1 Text Proposal for section 6: In-vehicle network topology, 9:
2 Traffic Separation and 11: Latency and congestion loss in IEEE
3 802.1DG/D1.3

4 Amrit Gopal
5 Ford Motor Company
6 October 2021

Figure: Example of Typical Automotive Network Architecture

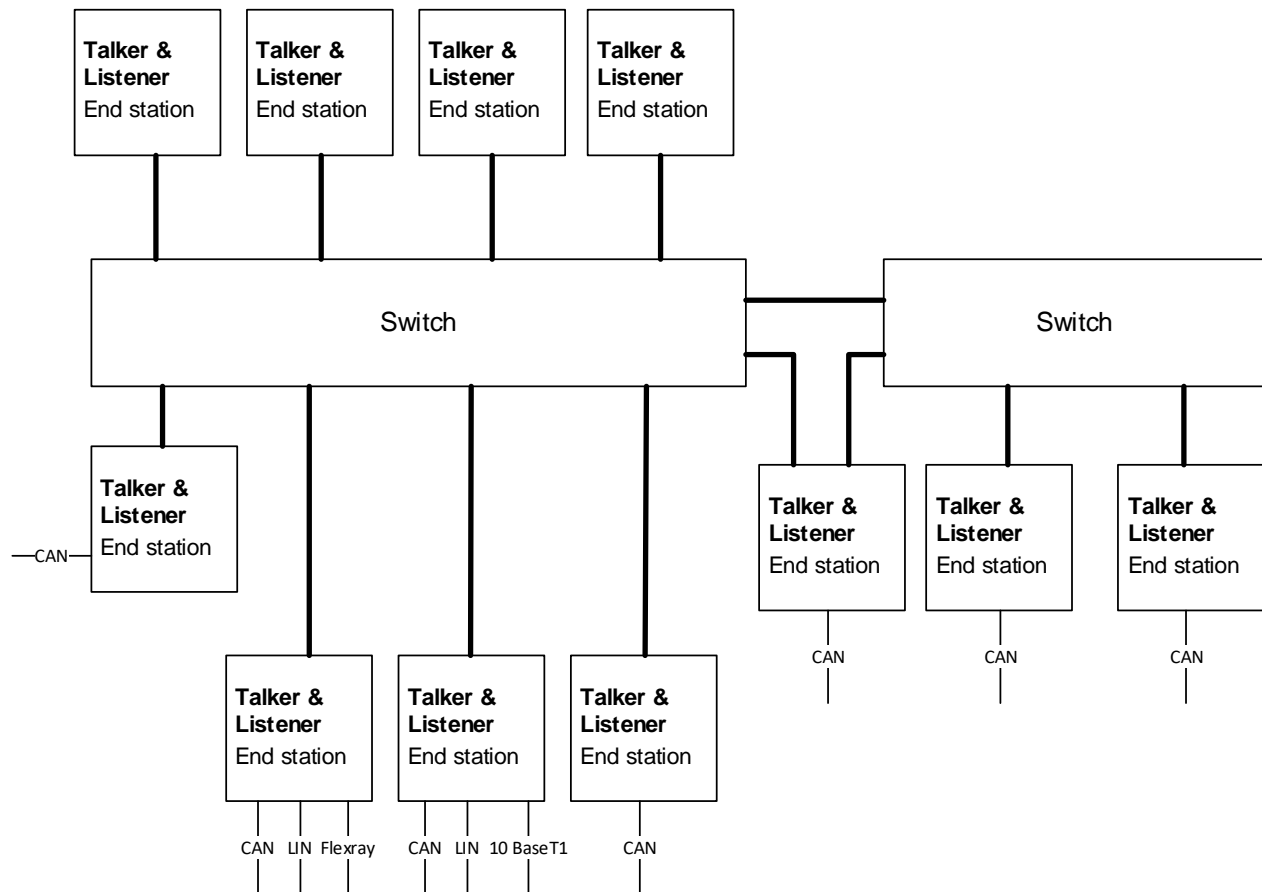
9 6.1.2 In-vehicle network topology considerations

Automotive Network Architecture
